ADDENDUM No. 4

August 11, 2021

Bid Number: **#75-2021**

Subject: West Hickman WWTP
Dewatering Improvements

**EXISTING MOTOR CONTROL CENTER (MCC-SPB)
NEW WORK PLAN - ALTERNATIVE NO. 1**

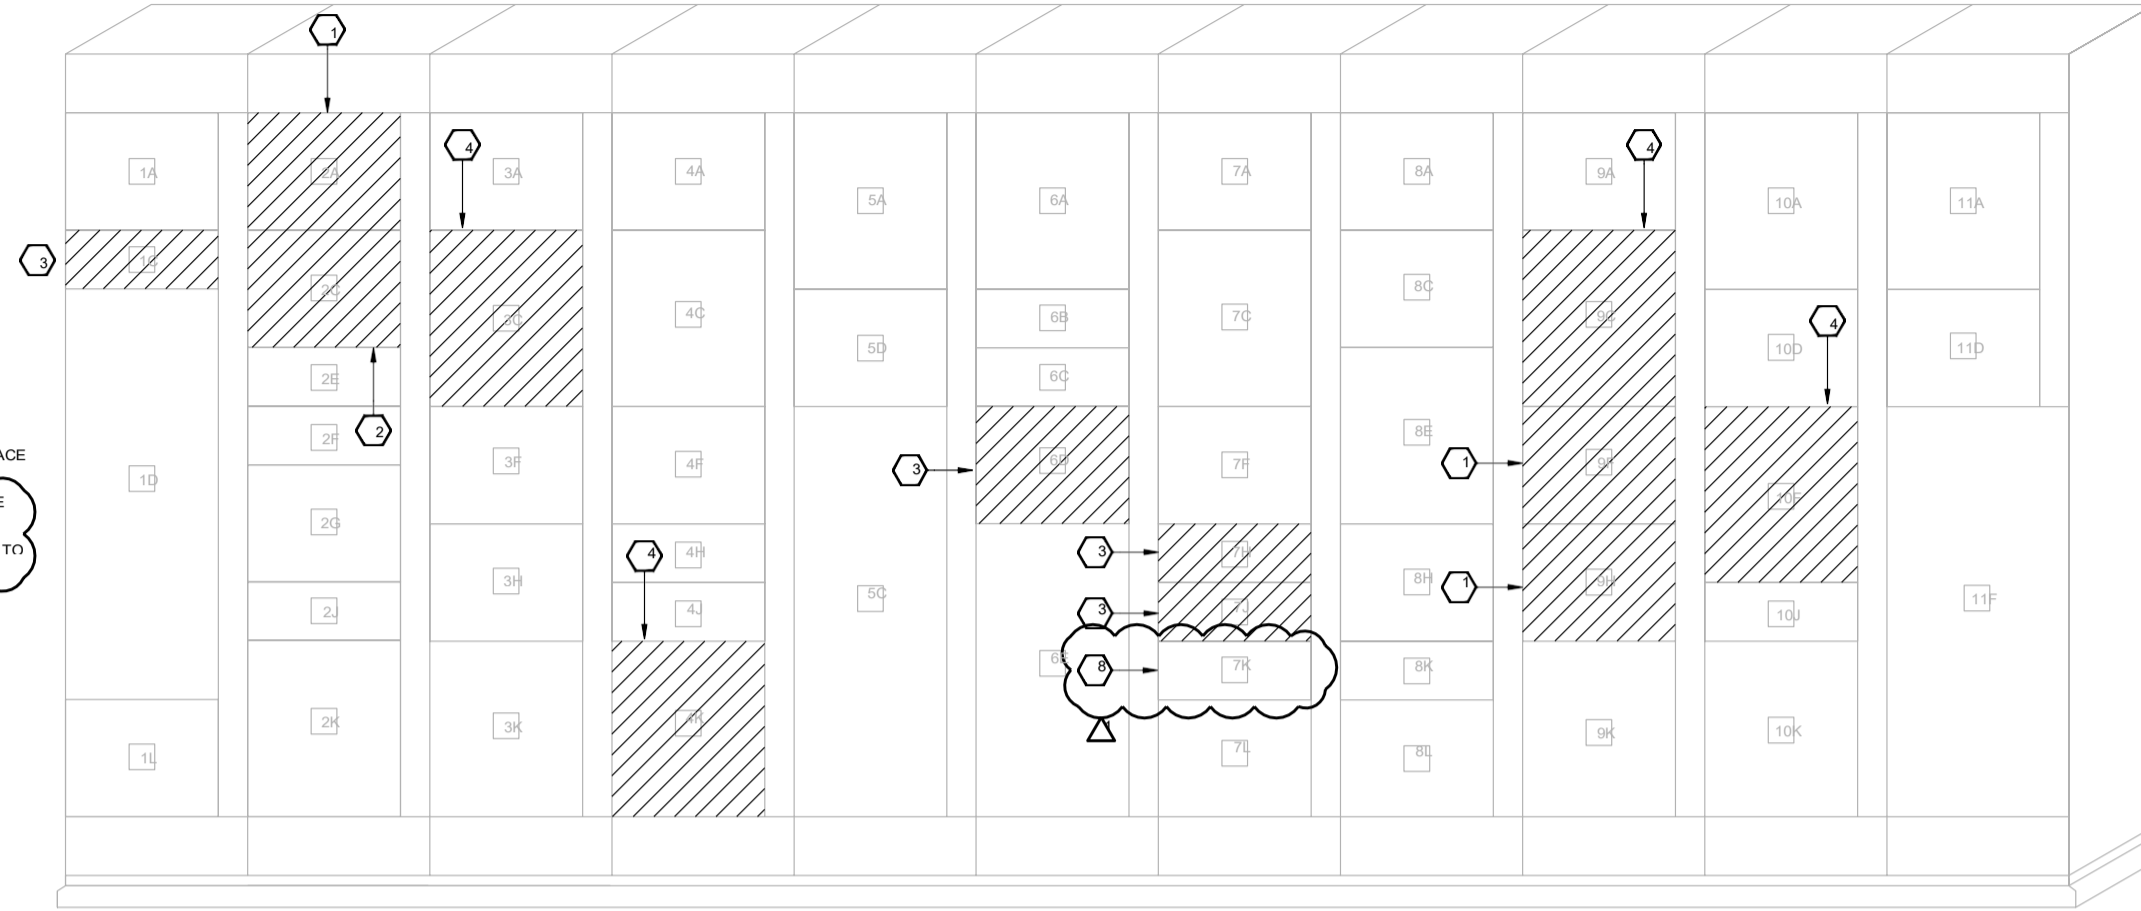
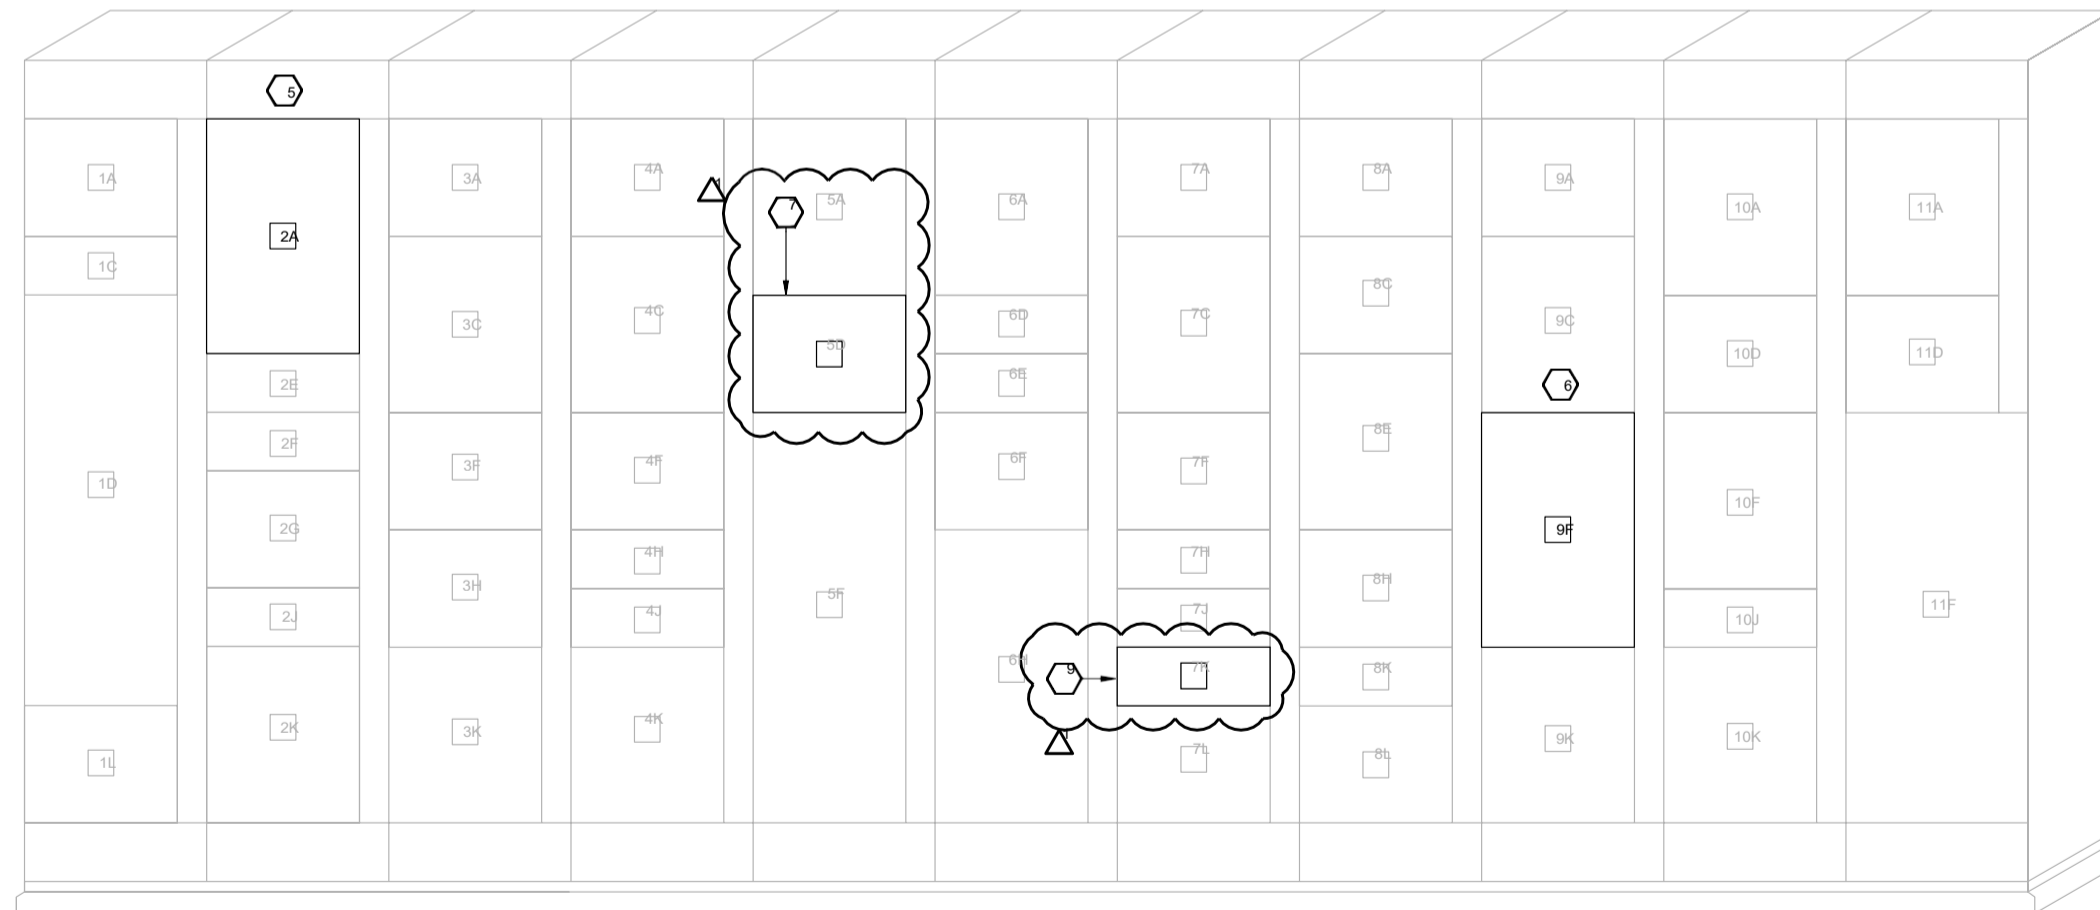
20.	Alternate #1 – Drawing E-00-601 shows the 20 Amp Breaker – Note #7 and the 40 Amp Breaker Note #8 being installed in Section 5D of MCC-SPB. For both breakers to fit into this section they would need to be ½ Space Factor Each. Allen Bradley says they need to be 1 Space Factor Each and will not fit as shown. Please provide revised modification drawings as to where they will need to be installed.	Please refer to Section 2 of this addenda – Drawings of required modifications.

Bid Number: **#75-2021****B. Sheet E-00-601**

1. Refer to attached drawing, sheet E-00-601, with Addendum No. 4 indicated in the revision section of the border. Note the area(s) shown clouded. The new auger conveyor control panel shall be feed from existing 50A/3P circuit breaker in MCC-SPB. The 20A/3P circuit breaker for the main output conveyor control panel shall be installed in MCC space 5D.

2 EXISTING MOTOR CONTROL CENTER (MCC-SPB)
NEW WORK PLAN - ALTERNATIVE NO. 2
NOT TO SCALE

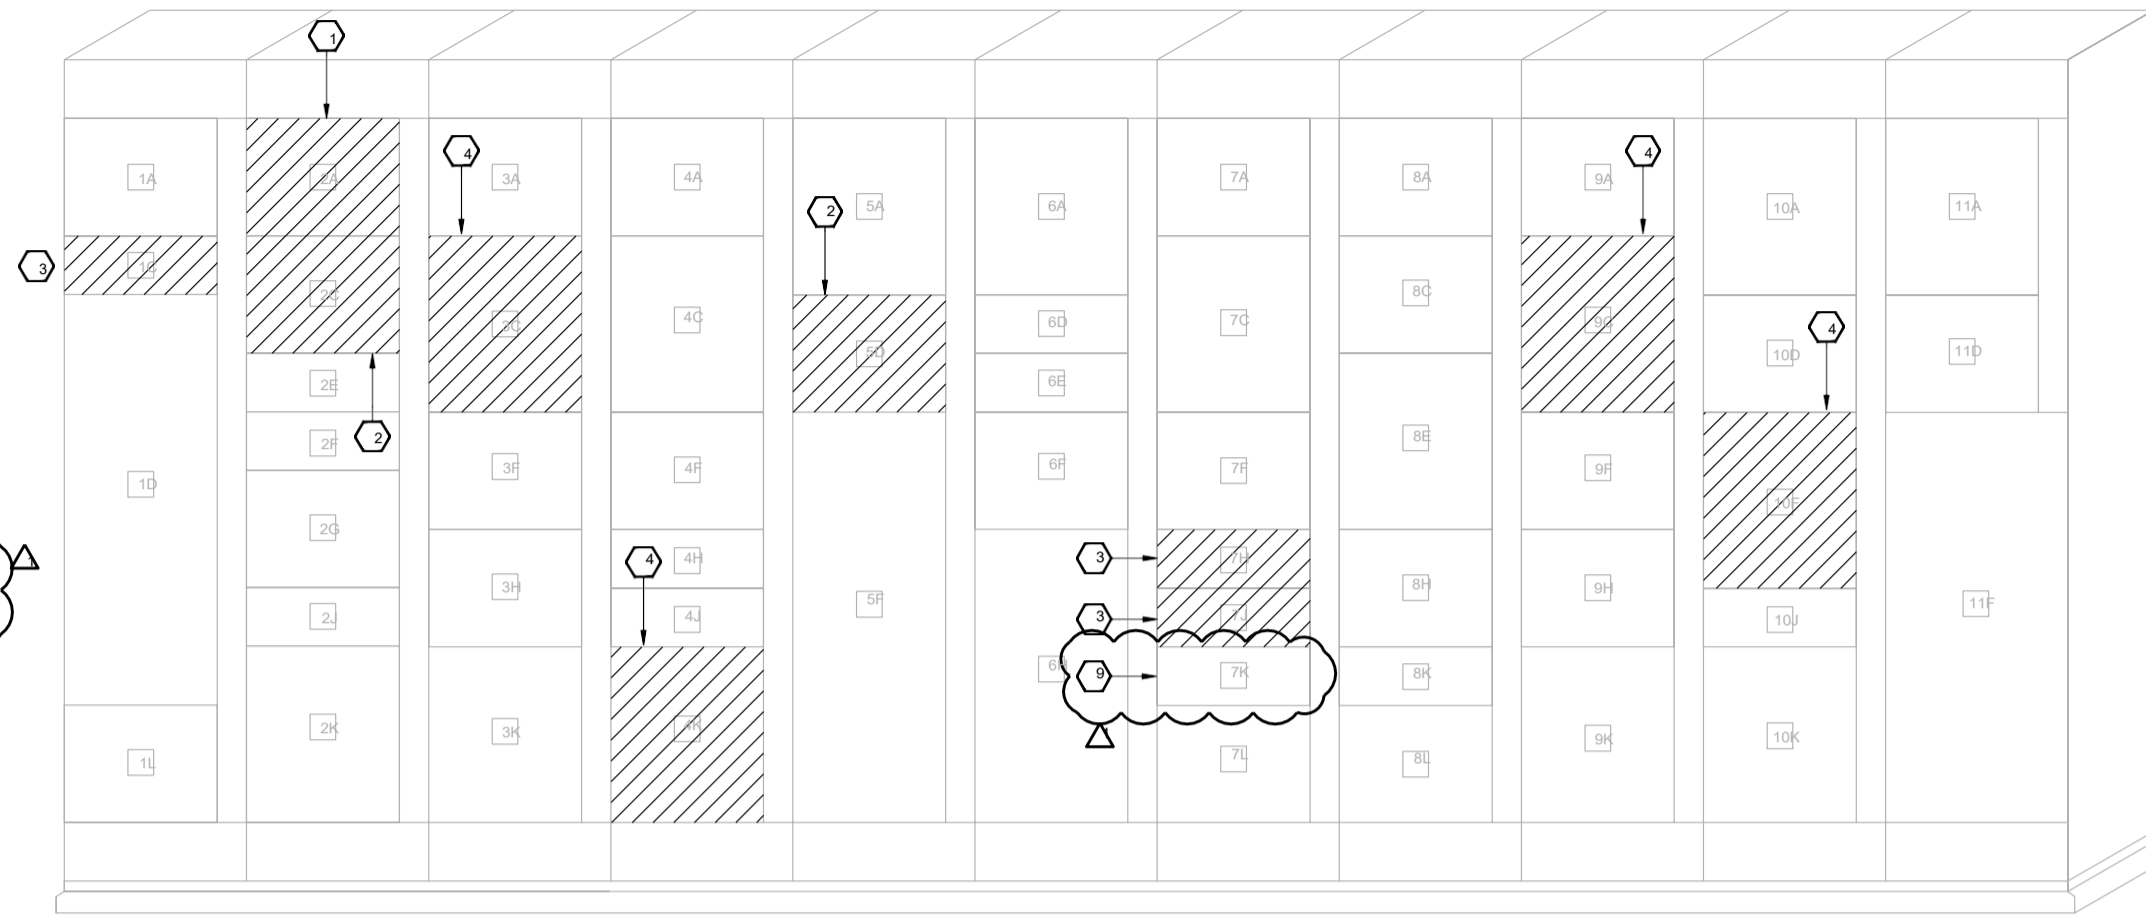
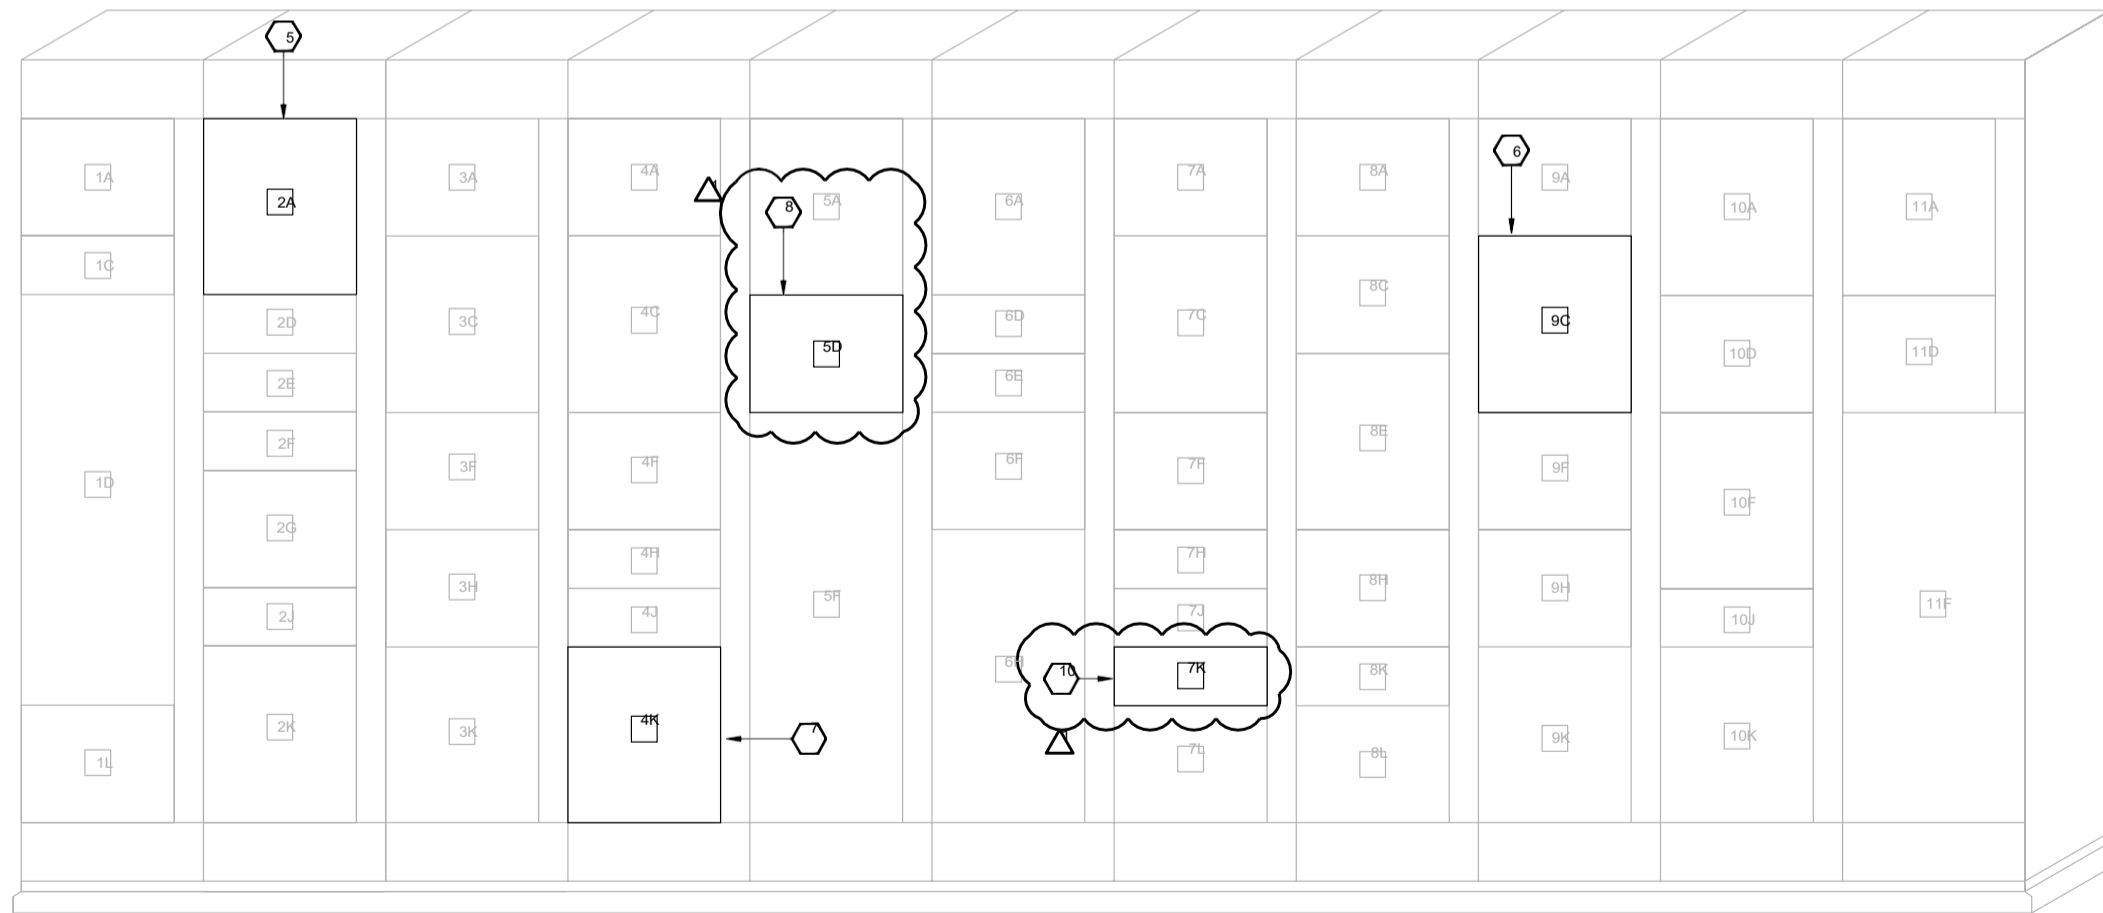
21.	<p>Alternate #2- Drawing E-00-602 shows the 20 Amp Breaker – Note #7 and the 40 Amp Breaker Note #8 being installed in Section 5D of MCC-SPB. For both breakers to fit into this section they would need to be ½ Space Factor Each. Allen Bradley says they need to be 1 Space Factor Each and will not fit as shown. Also in regards to the (3) 250Amp Breakers Notes #5, #6 and #7 they are shown being installed in section that is only 1 ½ Space Factor but are required to have a space factor of 2. Please provide revised modification drawings as to where they will need to be installed.</p>	<p>Please refer to Section 2 – Drawings of required modifications.</p>

C. Sheet E-00-602

1. Refer to attached drawing, sheet E-00-602, with Addendum No. 4 indicated in the revision section of the border. Note the area(s) shown clouded. The new auger conveyor control panel shall be feed from existing 50A/3P circuit breaker in MCC-SPB. The 20A/3P circuit breaker for the main output conveyor control panel shall be installed in MCC space 5D.
2. The feeder breaker size for Centrifuge No. 1, 2, and 3 shall be changed to 200A/3P. This size is adequate for the required load and will fit into the 1-1/2 spacefactor area as shown on the drawing.
